Development Permit Panel

Wednesday, July 26, 2017
3:30 p.m.

MINUTES

1. **DEVELOPMENT PERMIT 16-741123**
(REDMS No. 5433324)

Plan # M.a.

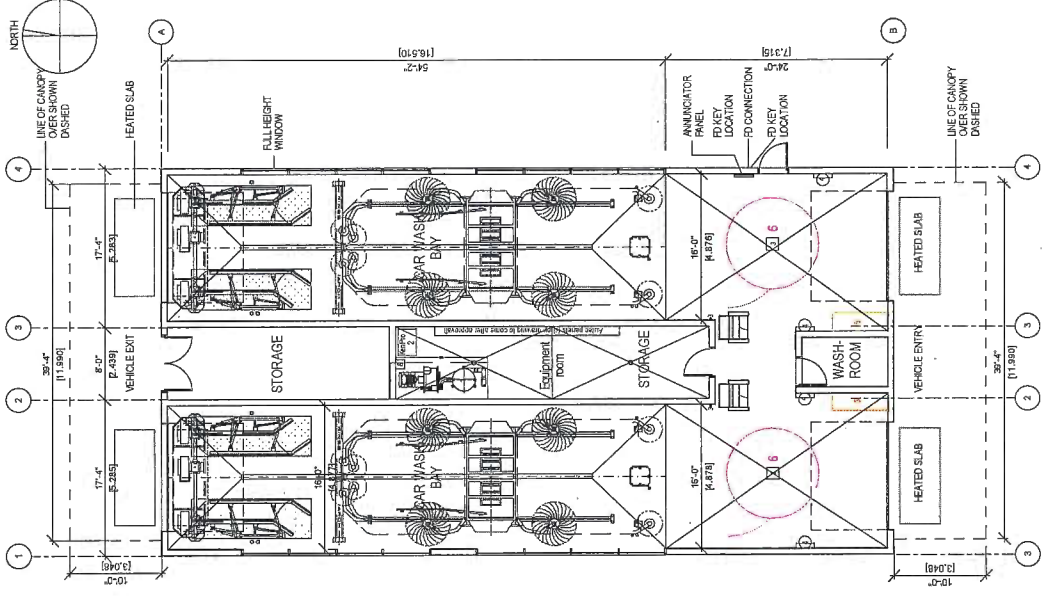
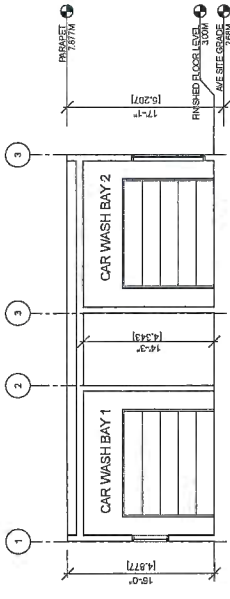
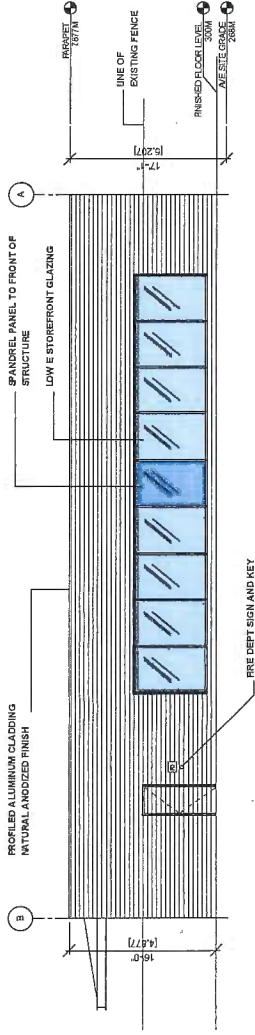
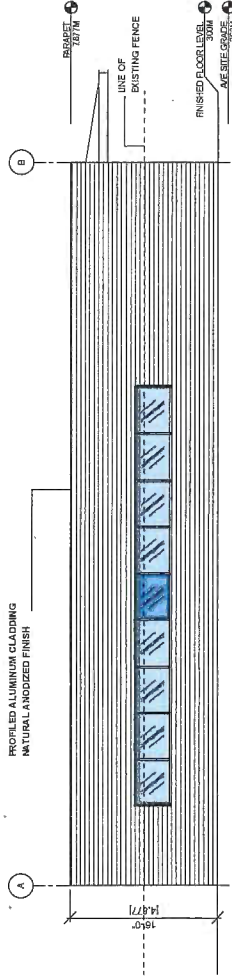
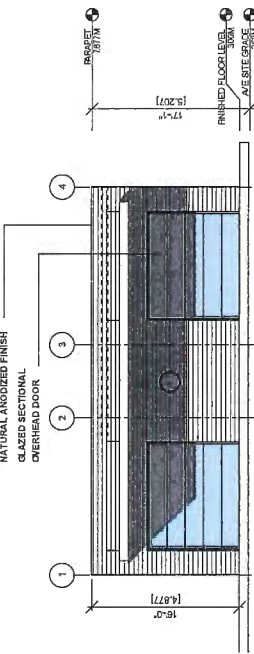
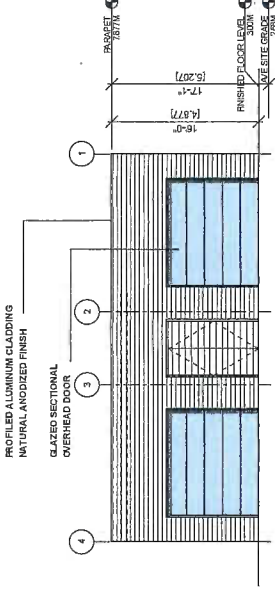
- *(Written comment submitted by Jubin Jalili and read into the record by Sara Badyal)*
- consider incorporating a water filtration system to allow re-use of water in the car wash facility to reduce the use of freshwater consumption;

- support the recommendation to move the car wash building further to the east to provide space for additional vegetative screening;

There is extensive planting and a fence proposed to the west side of the car wash, we believe this provides adequate screening to the car wash.

Green roof tiles have been added to the roof of the car wash building. Electric Vehicle Charging stations are incorporated on site.
